Lincoln-Lancaster County Health Department
ENVIRONMENTAL PUBLIC HEALTH DIVISION

Permit: SEWAGE INSTALLATION
SEPTIC SYSTEM

Establishment:
CANDI BRYANT
T7N R7E SEC 2
HOLLAND ACRES BLK 3 LOT 1
8400 LIGHTNER LN-HOLLAND

Request for Site Clearance and Permit

Soil Absorption Test Data Report
Annex to Application

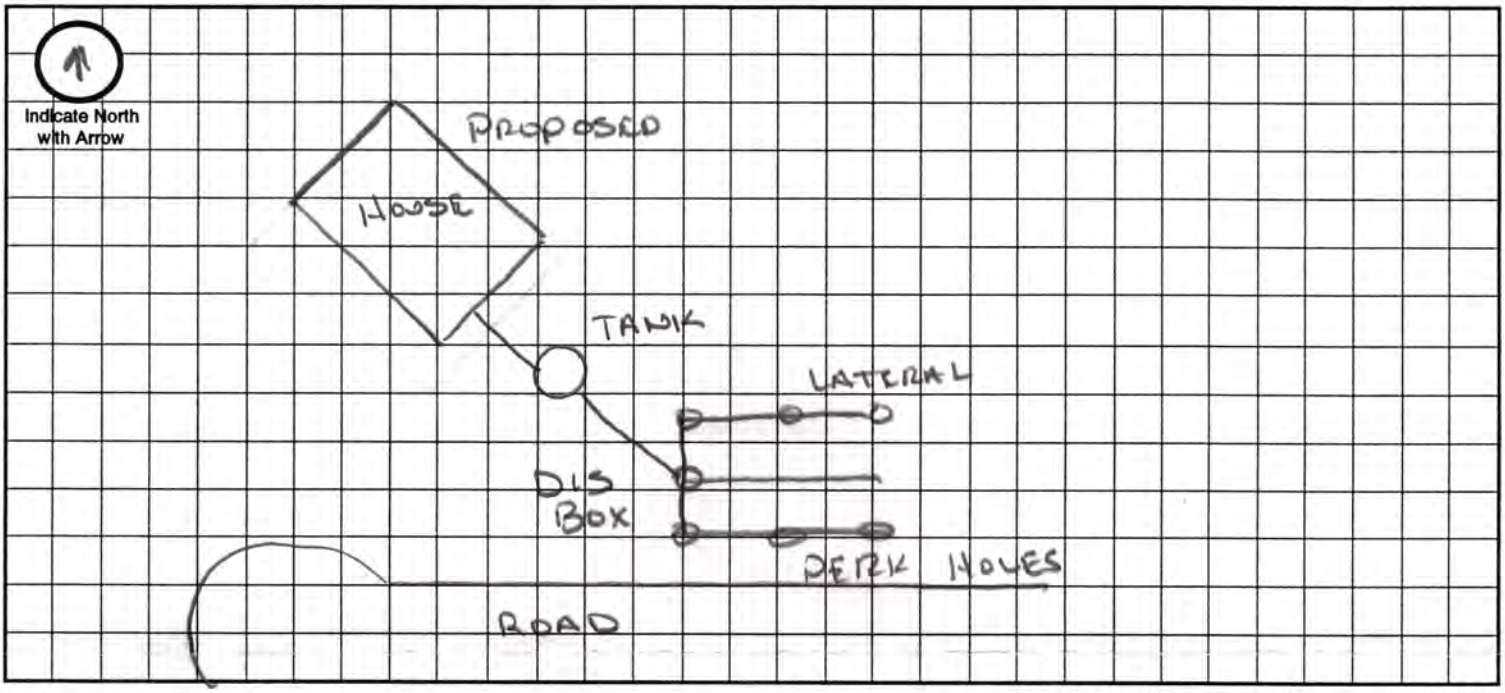
Remarks See Perc test Report: Because this Wymore inclusion is resting on Pawnee soil; the absorption field trenches must be shallow (20 to 24" deep) to keep the bottom of the trench an adequate distance above the impermeable clay layer of Pawnee soil.

STANDARDIZED SOIL PERC TEST REPORT

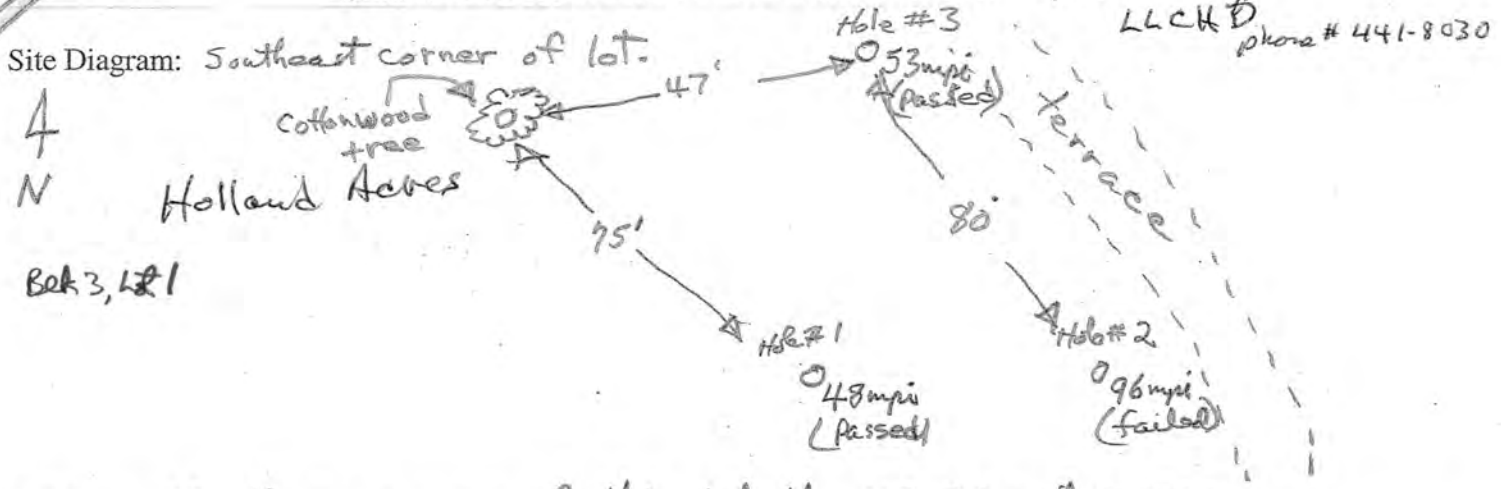
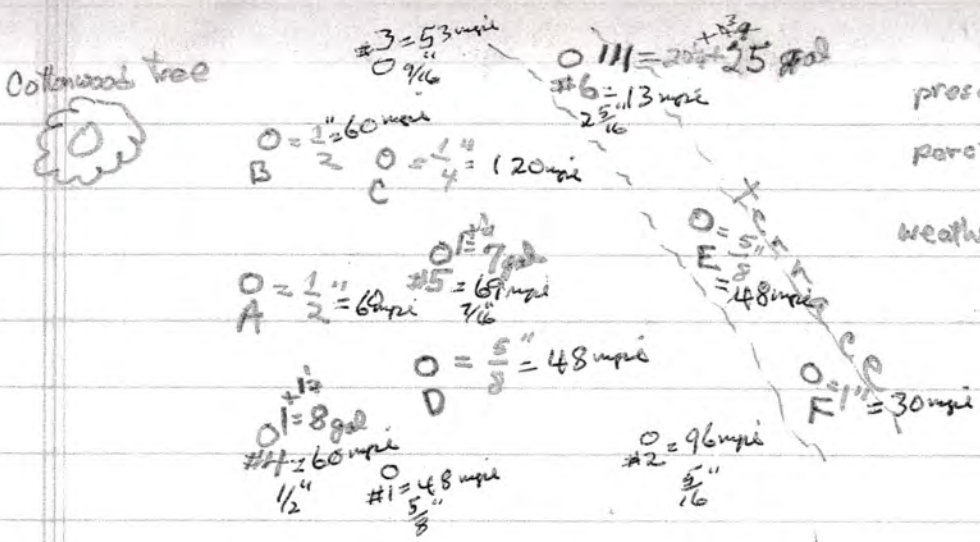
Soil Type: In the SE corner of this lot the U.S. D.A. soils map shows Pawnee and Mayberry glacial soils. these soil types are characteristically of high clay content and have very slow or failing perc rates. these soils have a perched water table 1 to 3 ft below the surface in the spring in some years. there is a small amount of Wymore soil in the northeast corner of this lot.

Comments: there appears to be an inclusion of Wymore type soils in the SE corner of this lot. this inclusion of a patch of wind-blown Wymore soil appears to be present on top of the slowly permeable glacial Pawnee & Mayberry soils.

Another perc test in this area with test holes evenly spaced over an proposed absorption field site in the SE corner of the lot may produce a passing perc rate in 6 or more holes. If a minimum of 6 test holes average 60 mpi or faster and vary by no more than 20 mpi between holes, then a conventional absorption field for an onsite septic system could be installed in this area.
